**TOWN OF BROOKLYN
PLANNING AND ZONING COMMISSION
Regular Meeting Agenda
Tuesday, March 21, 2023 6:30 p.m.**

- a. Reading of Legal Notices:
 - b. Continued Public Hearings:
 - 1. **SP 22-008:** Special Permit Application for Multi-Family Development (50 Condominium units) on south side of Louise Berry Drive (Assessor's Map 33, Lot 19), 13.5 acres, R-30 Zone, Applicant: Shane Pollack and Erin Mancuso.

**TOWN OF BROOKLYN
PLANNING AND ZONING COMMISSION
Regular Meeting
Wednesday, March 1, 2023 6:30 p.m.**

NORMAND THIBEAULT, JR., P.E. No. 22834 DATE

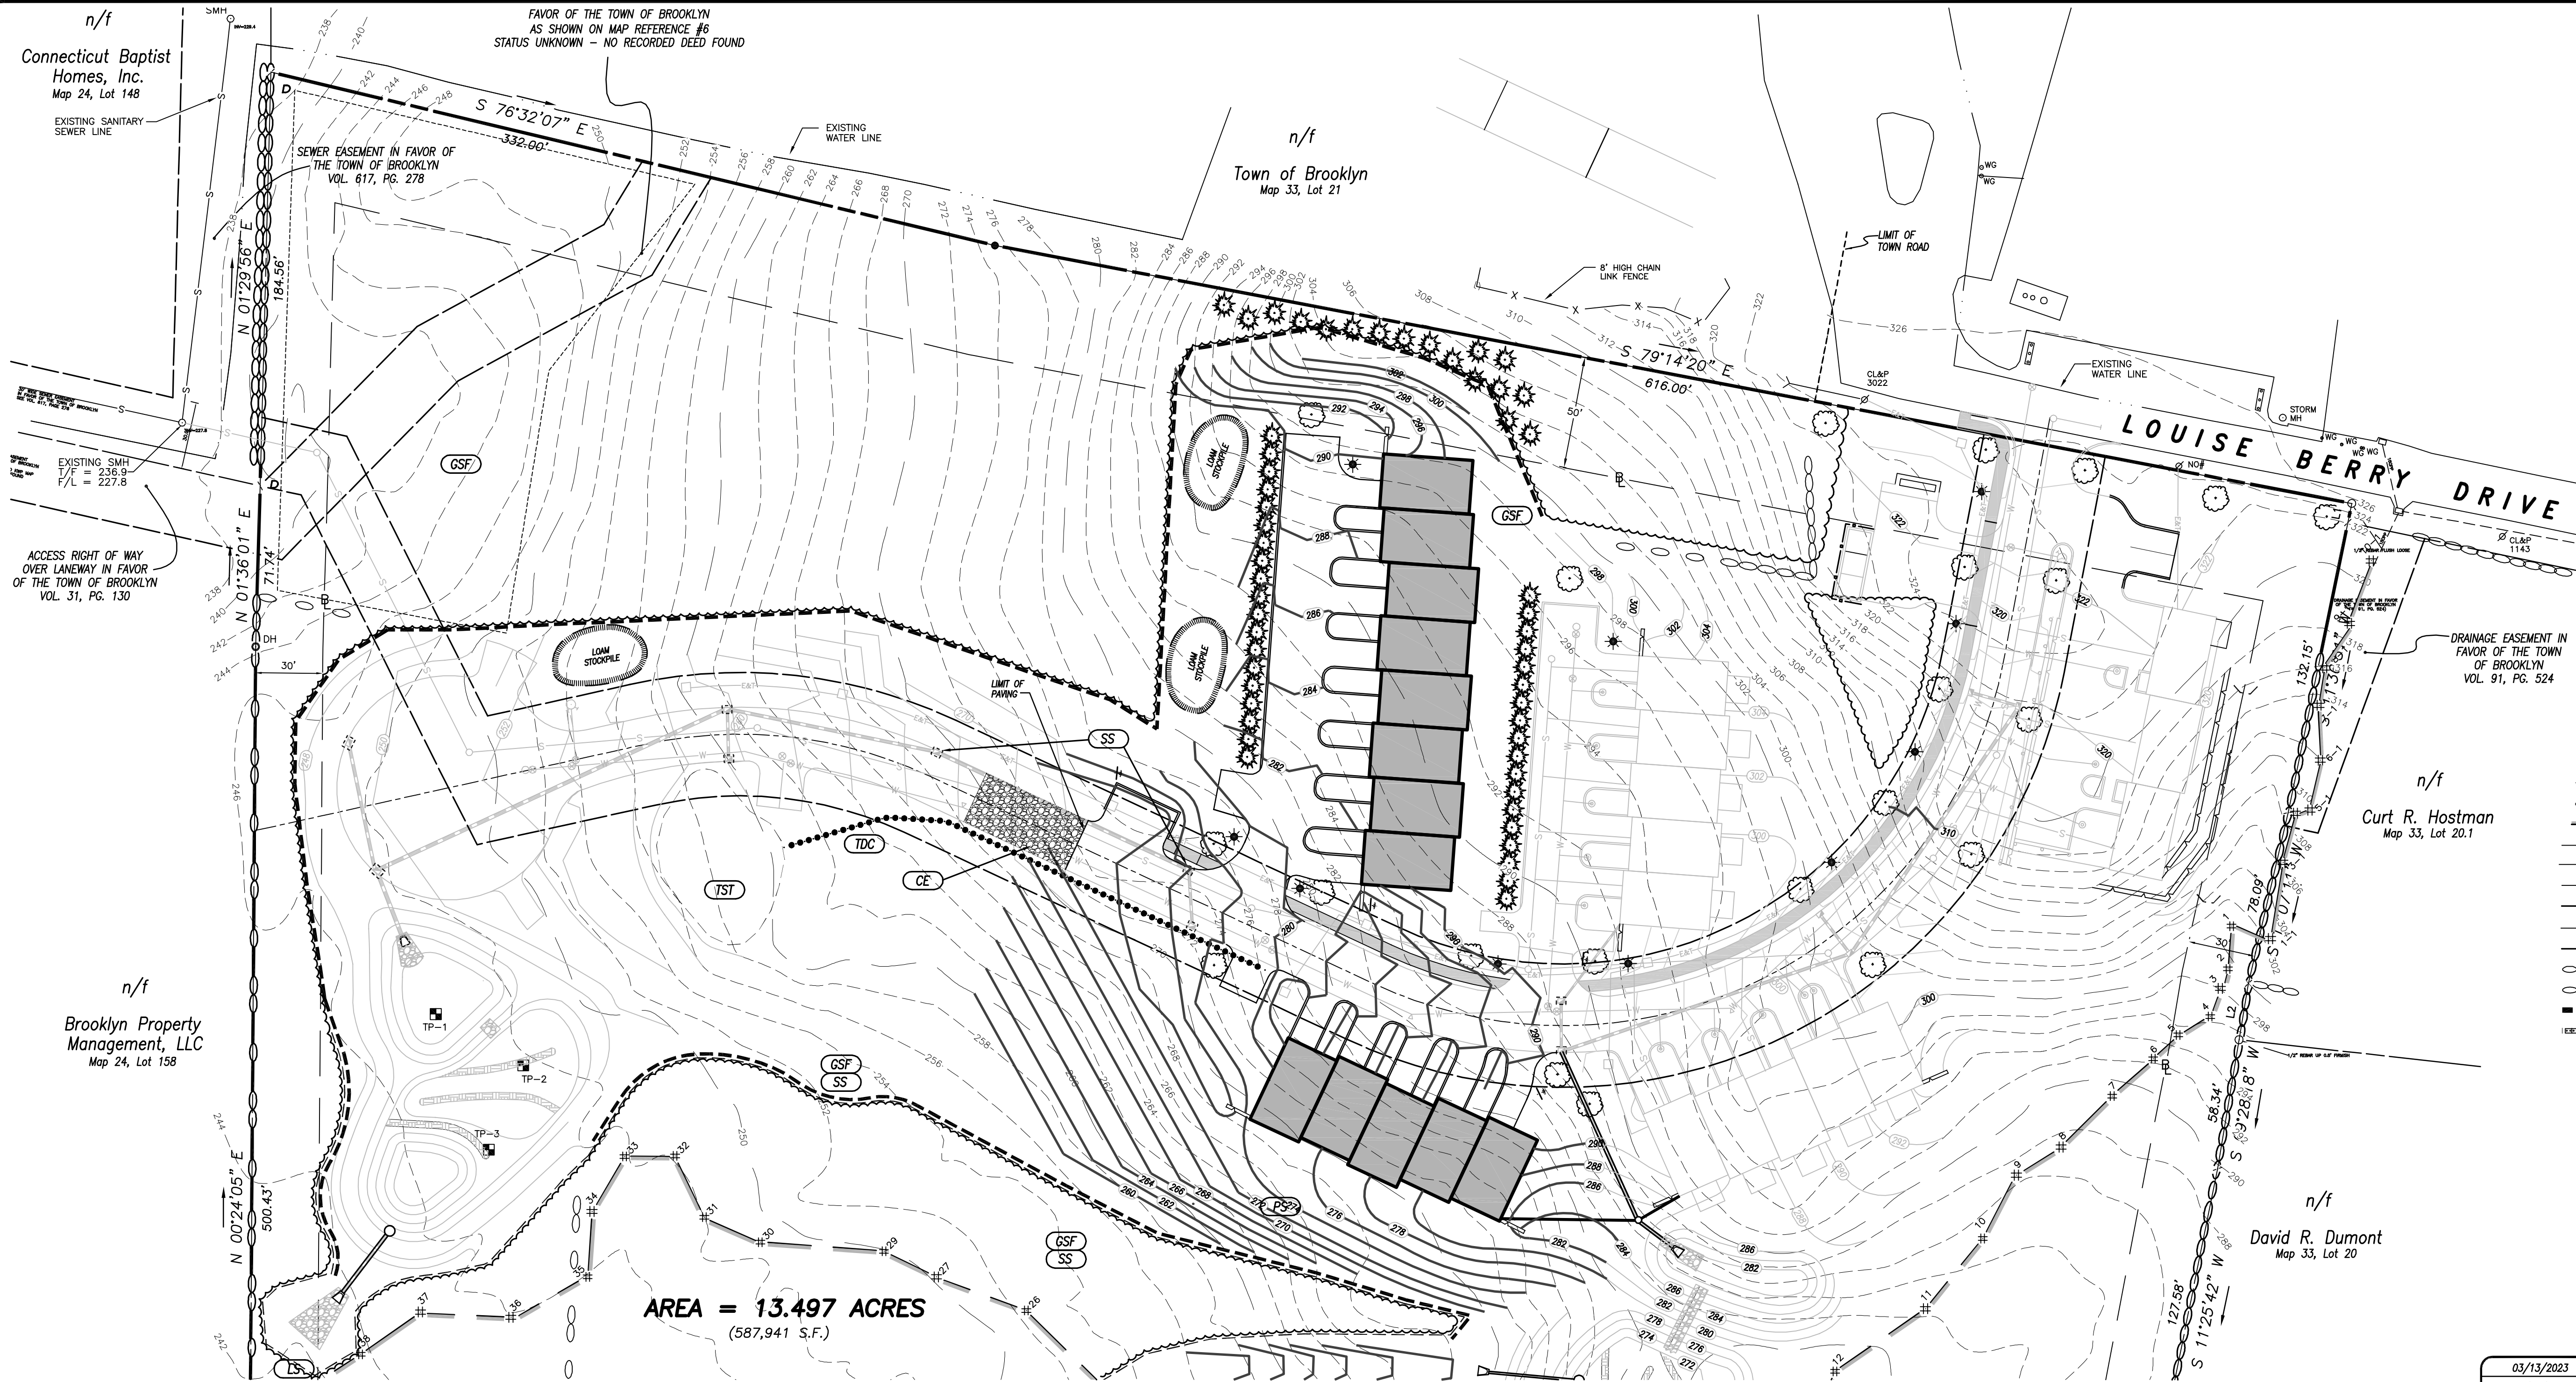
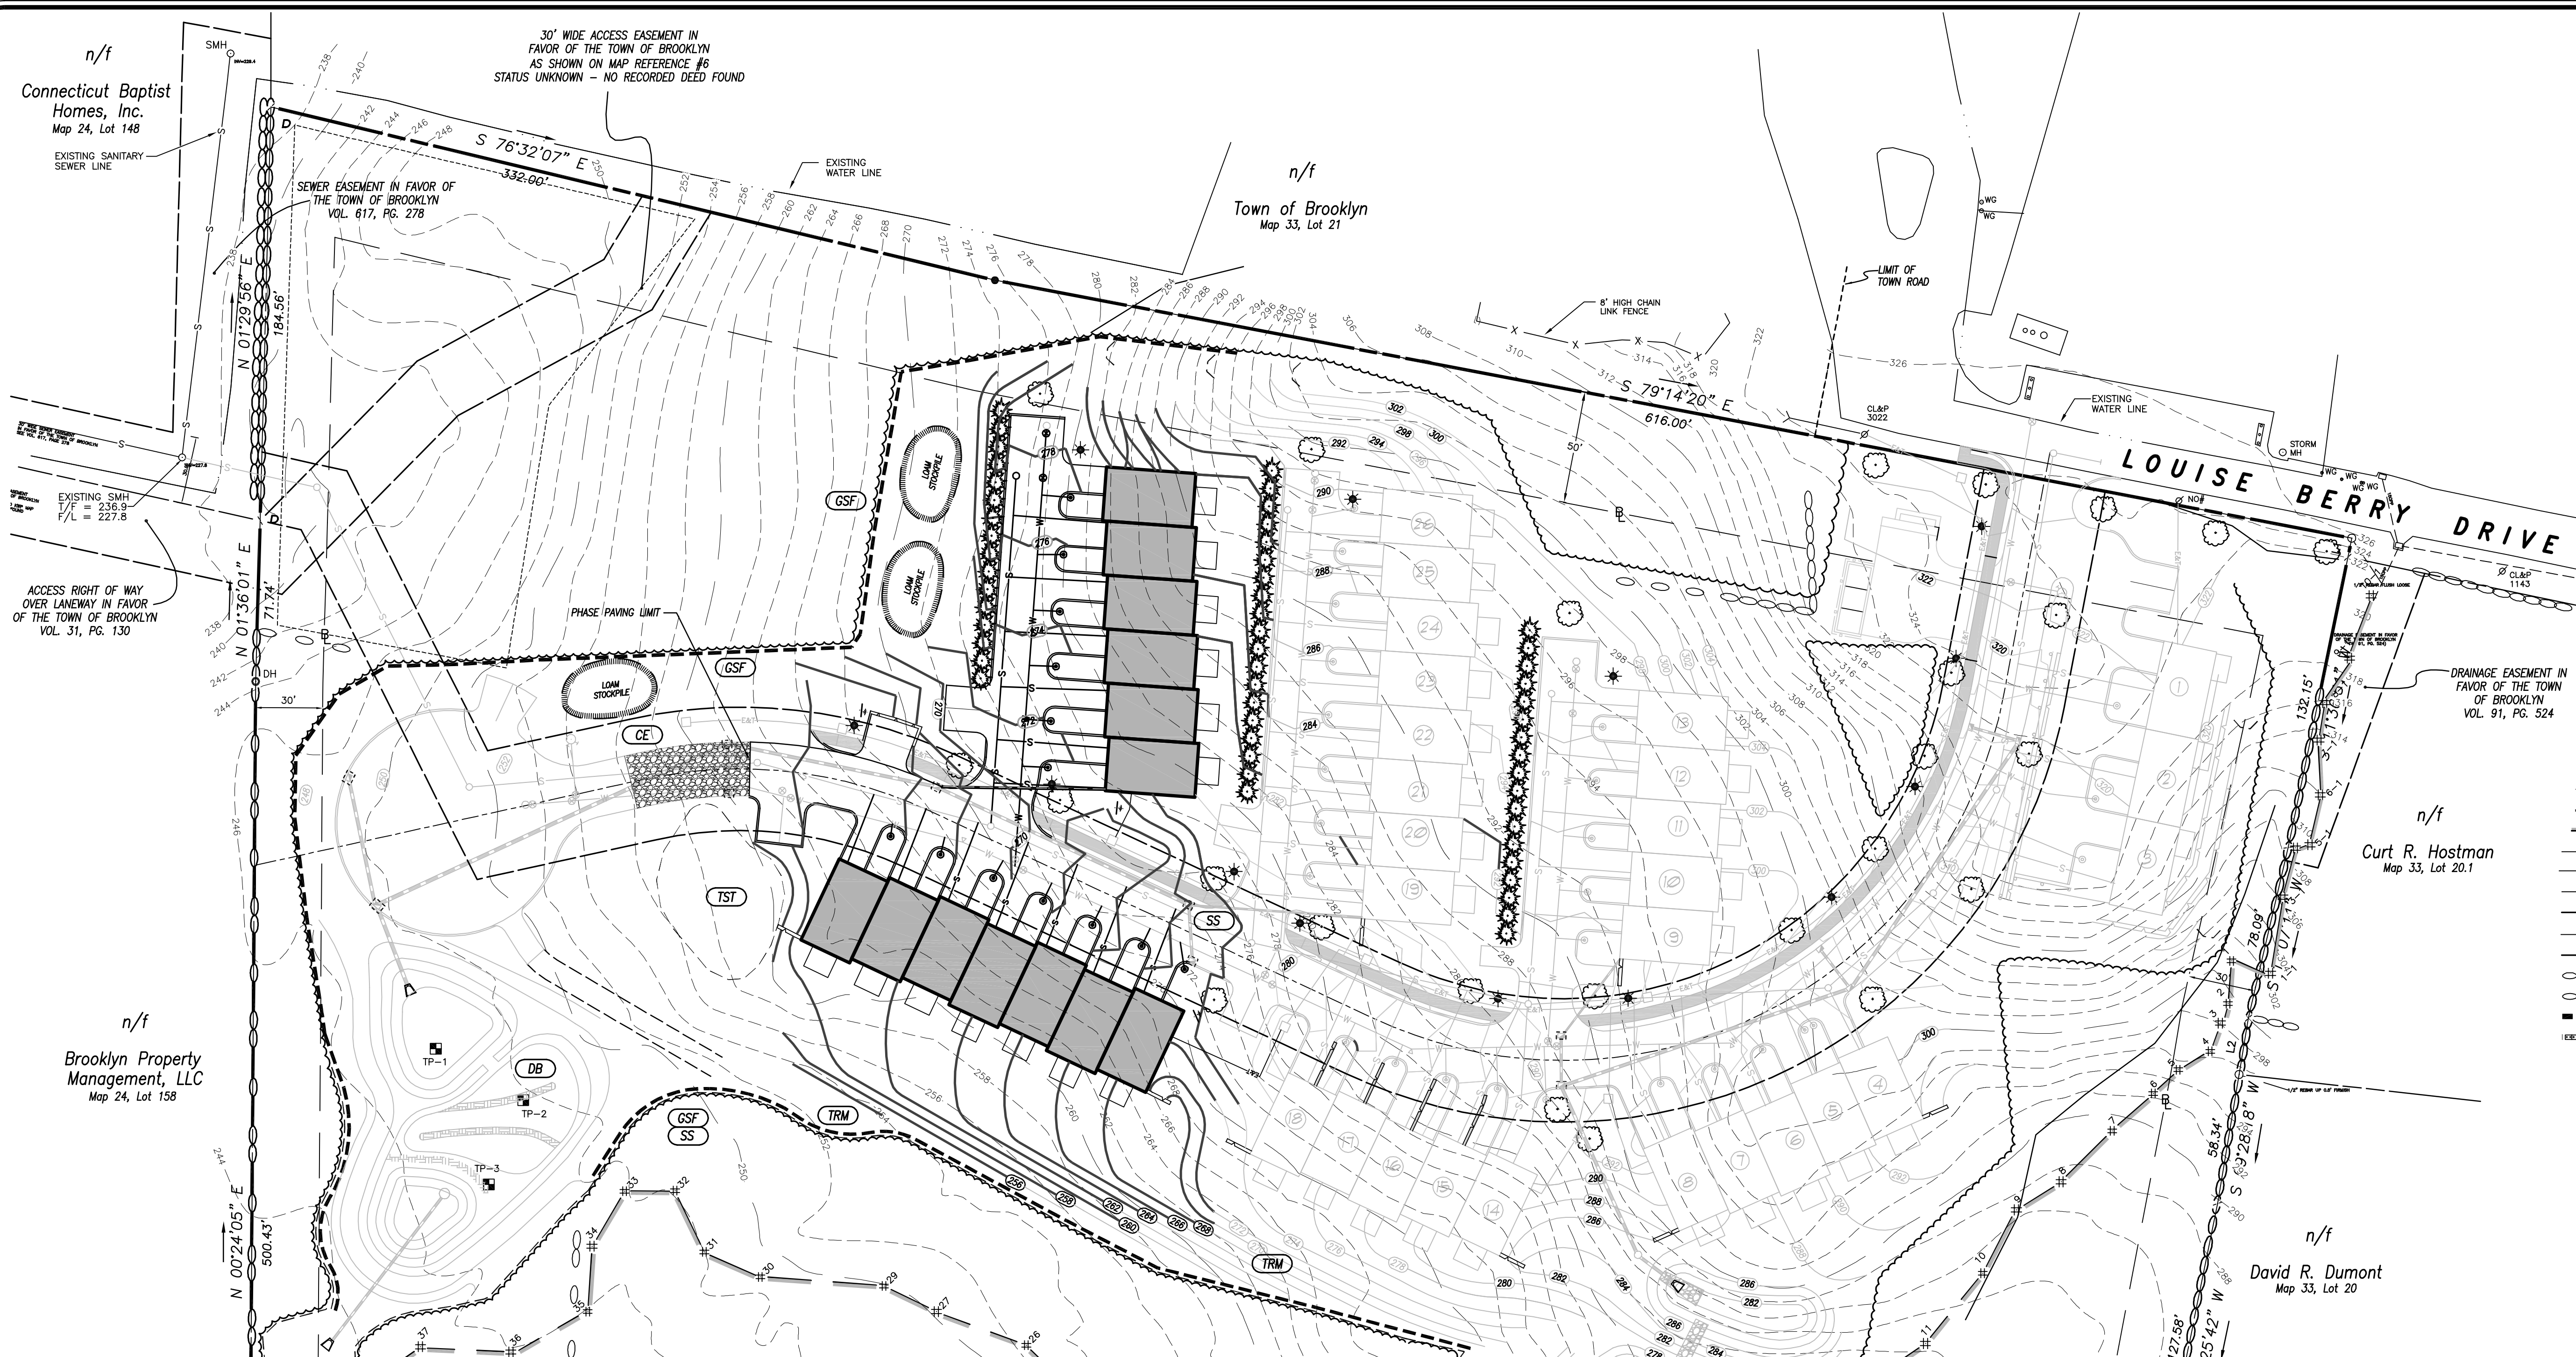
#1 - They are showing every phase to be paved. The sequence of construction on the Detail Sheet shows that the final course of paving will be installed upon completion of each phase.

#2 - They shaded the sidewalk areas on the phasing plans to make them more visible.

#3 - They added tree plantings to the phasing plans.

#5 - They added on-street parking to the phasing plans.

#6 - They added road centerline to the phasing plans.

#7 - They added stockpile areas to the phasing plans.

#8 - The proposed contour lines for the phases are a result of the final paving. He explained that there is a transition between phases as those contours have to be tied-into existing grades. He said that, for the most part, the contours are consistent with the overall plan.
